Cobrum Pty Ltd

Access Design Assessment Report

Section 4.56

Project: 22 Frenchs Forest Road East, Frenchs Forest
 Document Type: Access Design Assessment Report
 Our Reference: P218_051-6 (ACCESS) KG

Figure 1 – Pedestrian Entry

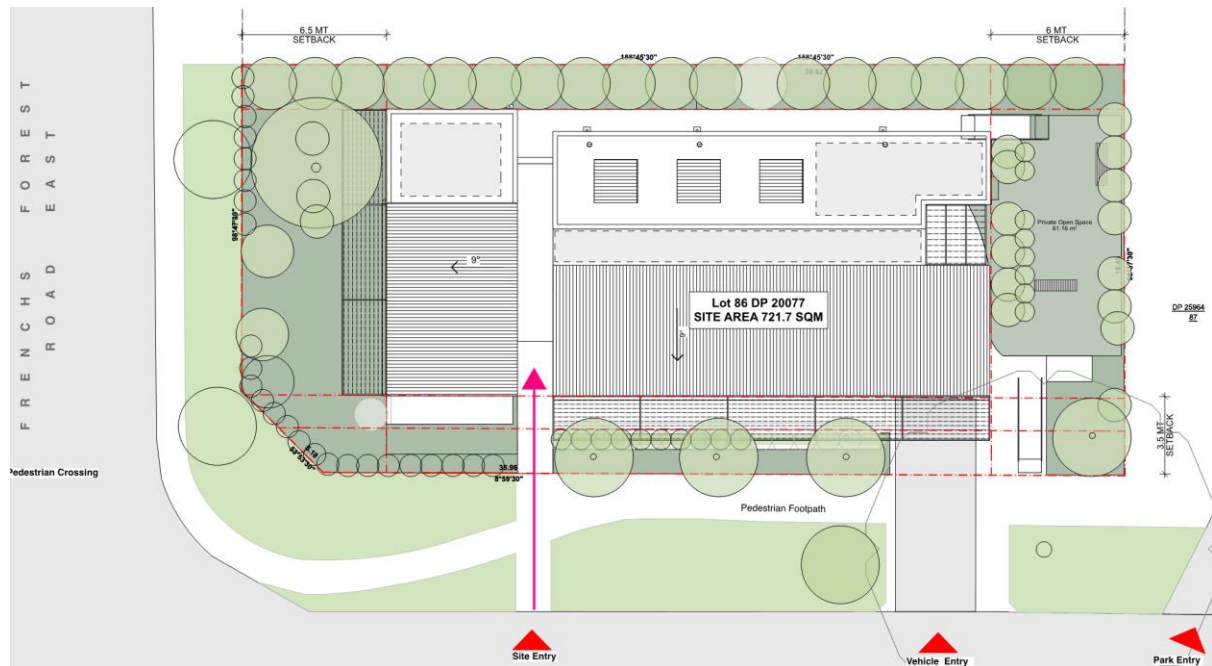
DESCRIPTION	COMPLIANCE DEPARTURE	RESOLUTION
General	It appears compliance with this clause is readily achievable.	Nil further action required at this stage.
